City of El Paso – City Plan Commission Staff Report

Case No:	SUSU14-00023 – Kern View Estates Unit Two Replat A
Application Type:	Resubdivision Combination
CPC Hearing Date:	March 26, 2015
Staff Planner:	Nelson Ortiz, (915) 212-1606, ortiznx@elpasotexas.gov
Location:	East of Stanton and North of San Mateo
Acreage:	15.5757 acres
Rep District:	1
Existing Use:	Vacant
Existing Zoning:	R-3 / P-R 1/c (Residential / Planned Residential/condition)
Proposed Zoning:	R-3 / P-R 1/c (Residential / Planned Residential/condition)
Nearest Park:	Mission Hills Park (.23 mile)
Nearest School:	Mesita Elementary School (.70 mile)
Park Fees Required:	$83,570.00
Impact Fee Area:	N/A
Property Owner:	Piedmont Group, LLC
Applicant:	Piedmont Group, LLC
Representative:	Brock & Bustillos, Inc.

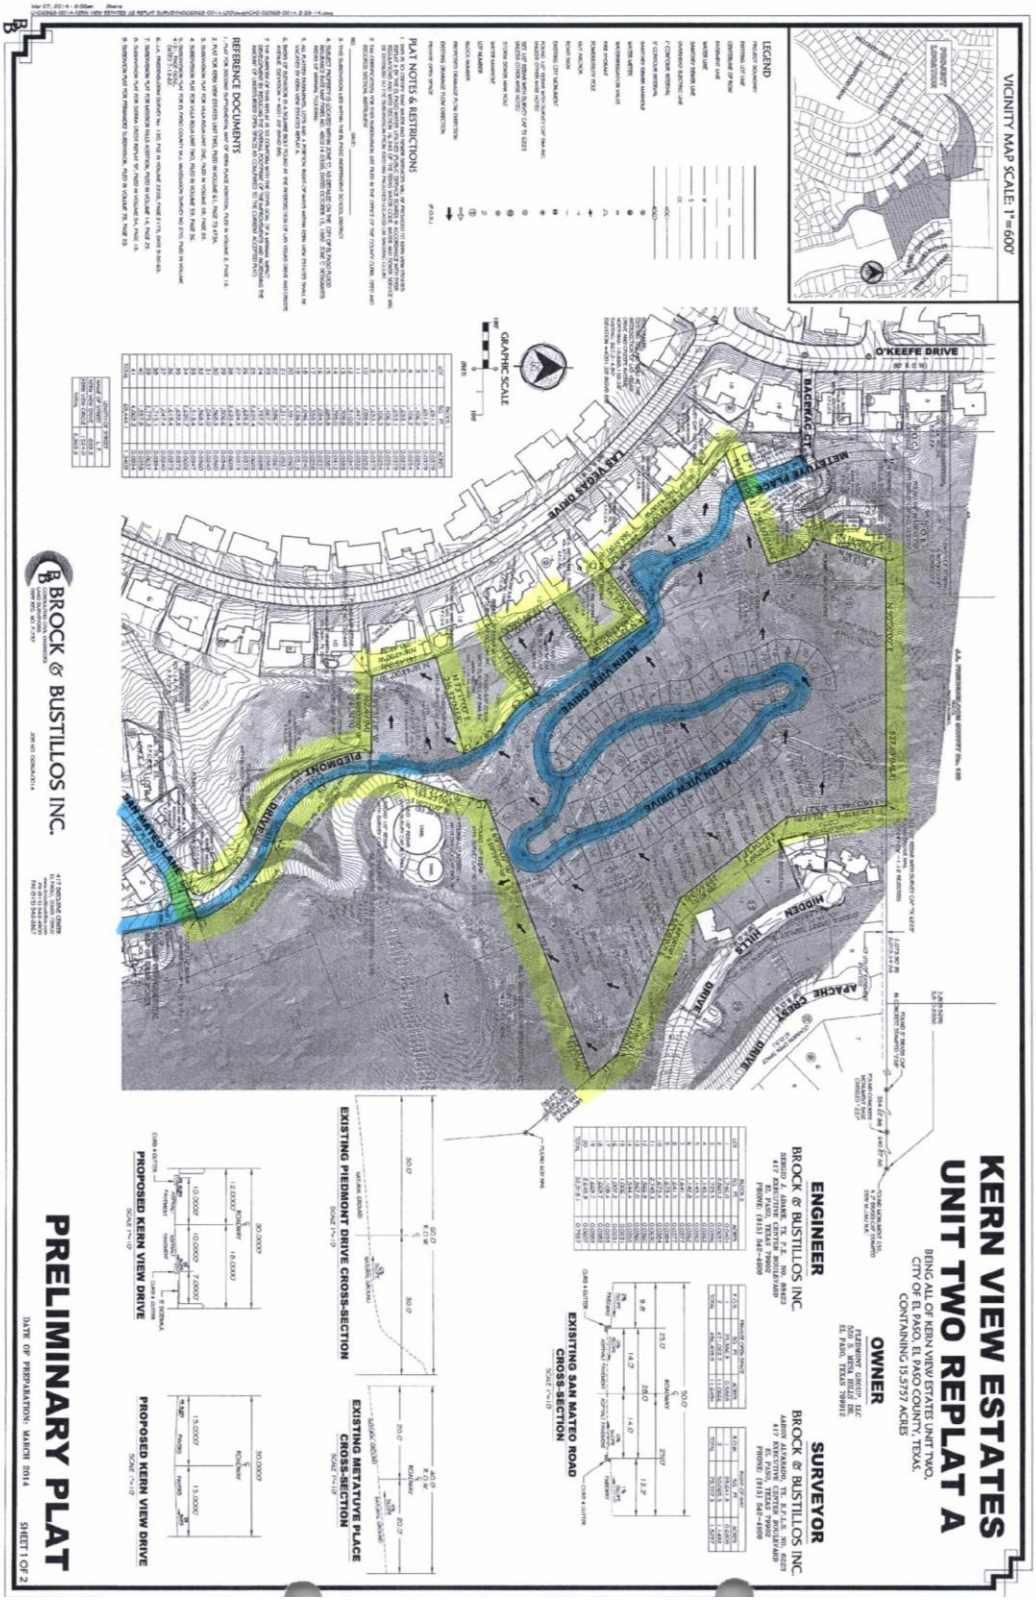
1. Verify line of sight for proposed monuments along drives.
2. On the street cross-sections, need to label the slope and direction.
3. Provide cross section for proposed future private Piedmont Drive.
4. Show proposed drainage flow patterns and contours on the preliminary plat. Identify the discharge location for all storm-water runoff.
5. Verify safe conveyance of the existing watercourse through the developed subdivision and show that all downstream storm-water management facilities have sufficient capacity to carry the additional runoff.
6. Provide a note on the plat indicating the entity responsible for maintenance of private drainage easement and private open space.

- Addressing shall be displayed on the plat.
